**ADDENDUM 1**  
**Request for Bids**  
**OJRSA Project #2026-02**  
**General Water Reclamation Facility Installation Projects**  
**August 21, 2025**

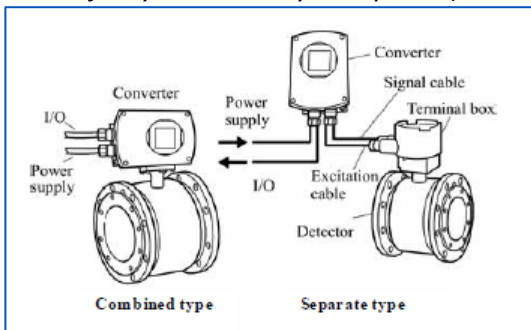
RAS Mag Meter - Please confirm if this will be an integral or remote flow meter (see below) and the length of cable that should be provided. *Please advise if Toshiba is an acceptable manufacturer. If so, please advise if 10 year warranty is required (standard from Toshiba):*

**Answer 2: THIS RFB IS NOT A REQUEST FOR PROCUREMENT OF EQUIPMENT AND MATERIALS, IT IS FOR INSTALLATION SERVICES.** Other than those pre-purchased items disclosed in the RFB, it will be up to the qualified contractor that is awarded the bid in accordance with the requirements stated in the RFB to select and purchase necessary materials and equipment. The comments regarding a request for additional information may be addressed at the mandatory pre-bid conference to be held at the date, time, and location as stated on the cover of the RFB.
